## Diversified Metal Fabricators Service Bulletin SB 2045

<b>Title</b>	RW-1013 Railwheel Bearing Hardware & Adjustment
<b>Document No.</b>	2045 rev A
<b>Issue Date</b>	7/22/05 <b>Revision C 7/19/10</b> (WAK )
<b>Units Affected</b>	All units with RW-1013 railgear – Supersedes SB-2042
<b>Purpose</b>	<ul style="list-style-type: none"><li>To call attention to a service issue with the bearing hardware used in RW-1013 railwheels.</li><li>To provide information and guidance to those involved in service and inspections.</li></ul>

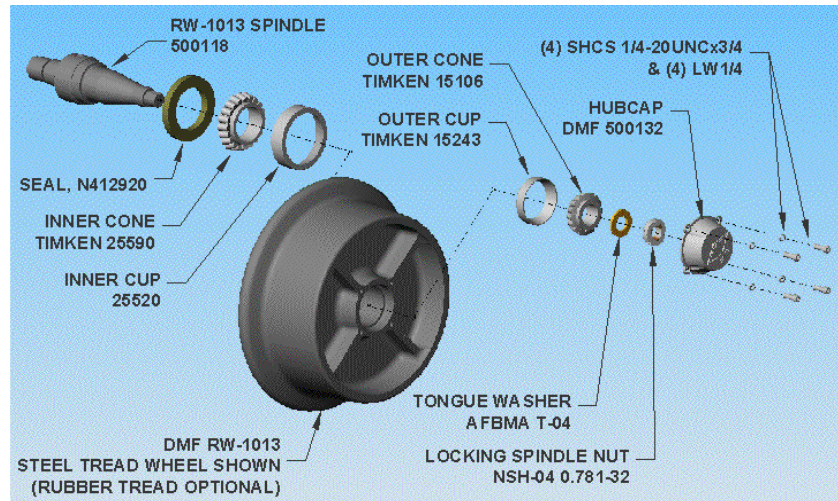
There have been cases of RW-1013 railwheels becoming loose or coming off RW-1013 equipped vehicles. To address this, the revised spindle nut includes (3) brass shoes engaged by set screws to prevent these problems. The tab washer is no longer used, the tongue washer is still used. This Service Bulletin supersedes SB-2042.

The previous nut (N-04) has four flats and may have a brass tipped set screw. The new spindle nut (NSH-04) has three flats, three set screws and three brass shoes.

ALL RW-1013 UNITS MUST HAVE THE SPINDLE NUTS REPLACED WITH THE REVISED NUT.

1. Assemble components as shown in attached assembly drawing.
2. Tighten spindle nut to approximately 25-50 ft-lbs
3. Rotate wheel one full turn in each direction
4. Loosen spindle nut
5. Tighten spindle nut by hand while turning wheel until snug.
6. Back off spindle nut ¼ turn and ensure that the brass shoes are clear of the keyway. (1/4 turn should give the recommended 0.005" to 0.010" of endplay)
7. Tighten set screws progressively to 20-35 in-lbs. **Ensure that Allen Key is fully inserted to avoid rounding out socket set screw..**

- **The brass shoes must be loosened and "released" prior to disassembly! Failure to do so requires replacement of the NSH-04 nut.**
- **To release the shoes prior to disassembly, tap the nut at each (3) screw position after loosening the set screws.**
